Interactive comment on “Gauge-Adjusted Rainfall Estimates from Commercial Microwave Links” by Martin Fencel et al.

Received and published: 1 November 2016

Fig. 1. Comparison of R^2 for different temporal aggregations of reference rainfall. Mean of four CMLs (see figure 2 of the original manuscript) adjusted to rainfall having different aggregation intervals

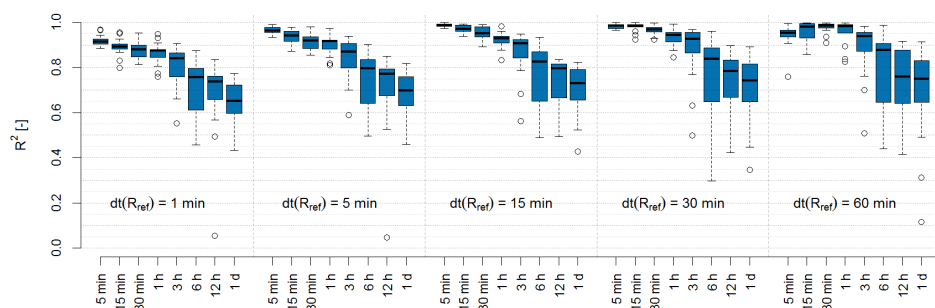
6. Section 2.6. You state that you adjust on different aggregation levels ranging from 5 min to 1 day, but compare on 1 minute values. Couldn't there be reason also to compare on larger aggregation levels than 1 min. It is well known that for small rain intensities rain gauges are not very accurate. E.g. one tip of 0.1 mm per minute in a tipping bucket rain gauge corresponds to 6 mm/h. An error of +/- 6 mm/h on gauge estimates over one minute for intensities larger than 6 mm/h, it therefore not unrealistic. For smaller intensities where the intensities are estimated using the time between two tips, the intensity at minute scale might be somewhat uncertain. In a paper (Thorndahl et al. 2014) we made radar-rain gauge adjustment over different temporal scales, but also compared the results over different scales. Maybe you could find some inspiration here.

Thank you for this suggestion. We used one minute reference data because this is the temporal resolution required for rainfall-runoff modeling at the scale of small urban catchments and our long-term intention is to provide rainfall data which could be used for this purpose. In the case of Dubendorf site, disdrometers are very well suited for providing rainfall data at 1 min resolution. The sampling error of tipping bucket RGs in Prague is partly reduced by calculating areal rainfall from six RGs relatively close to each other. Nevertheless, we agree that this sampling error may influence R^2 values. We have therefore compared rainfall estimates from CML data also at other temporal scales (Fig 1, this response).

We find only small changes in R^2 values when comparing CML rainfall to reference rainfall at larger temporal scales. This indicates that the analysis even at 1 min scale is not substantially influenced by random errors. Interestingly, we see a slight increase in R^2 values for larger temporal scales of reference rainfall, although aggregation should reduce RG sampling errors. In our view, giving a larger weight to the RG data in the adjusting procedure increases the R^2 , because the temporal scale of reference rainfall gets closer to the aggregation interval used for CML adjusting (for details see comment no. 11 of the reviewer 1). The results presented here do not, however, change our conclusions drawn in the original manuscript where we only presented the performance for 1 minute data.

Fig. 2. Experimental layouts projected into UTM coordinate system.

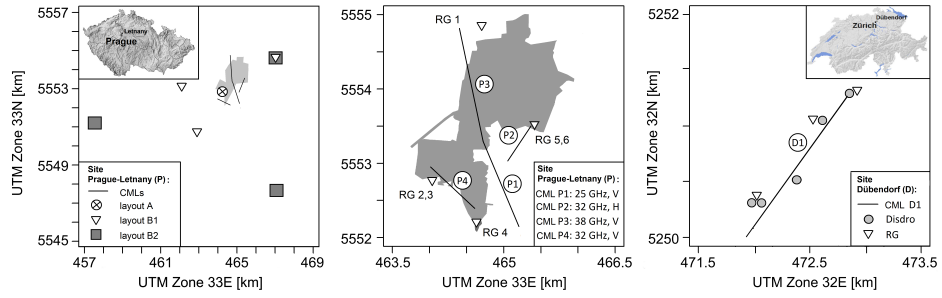
11. Figure 1. Please use lat/long or UTM rather than a local coordinate system.

Thank you for the suggestion. We will change it as shown in the Fig. 2 in this response.
